35-TYPE CONVERTER SETS — ADJUSTMENTS

APPARATUS AFFECTED: 35A, 35B, 35D, 35E, 35F, 35G and 35H Converter Sets.

- (1) To simplify adjustment methods and requirements.
- (2) To revise and update wiring diagrams.

8.19 GEAR MECHANISM

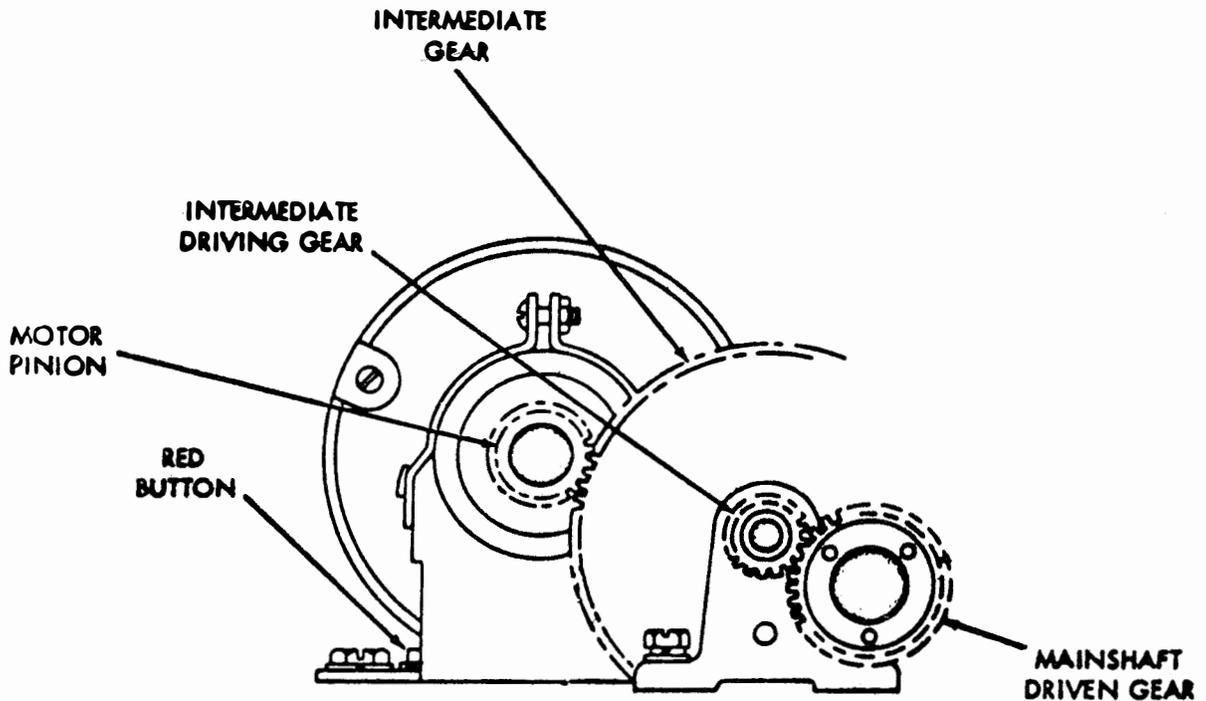
The requirement (A) Tape Reader Gear Backlash has been changed:

From: "Only a perceptible amount of backlash between main shaft driven gear and intermediate driving gear."

To: "Only a perceptible amount of backlash between main shaft driven gear and intermediate driving gear at point where backlash is least."

The requirement of Min. 0.015 inch—Max. 0.020 inch has been deleted.

"To Adjust" of new (A) Intermediate Shaft, has been changed:

From: To Adjust.

Position the intermediate shaft assembly to the forward plate loosened.

The note to subparagraph (B) Intermediate Shaft, has been changed:

From: Note: Intermediate shaft adjustment required only on miniaturized base.

(A) INTERMEDIATE SHAFT

ONLY A PERCEPTIBLE AMOUNT OF BACKLASH BETWEEN THE MOTOR PINION AND INTERMEDIATE GEAR AT POINT WHERE BACKLASH IS LEAST.

LOOSEN THE TWO INTERMEDIATE GEAR BRACKET SCREWS AND POSITION INTERMEDIATE GEAR BRACKET.

NOTE: IN SOME CASES IT MAY BE NECESSARY TO LOOSEN THE MOTOR MOUNTING SCREWS AND POSITION THE MOTOR TO MEET THE REQUIREMENT.

(B) TAPE READER GEAR BACKLASH

ONLY A PERCEPTIBLE AMOUNT OF BACKLASH BETWEEN MAINSHAFT DRIVEN GEAR AND INTERMEDIATE DRIVING GEAR AT POINT WHERE BACKLASH IS LEAST.

LOOSEN THREE TAPE READER MOUNTING SCREWS AND POSITION TAPE READER.
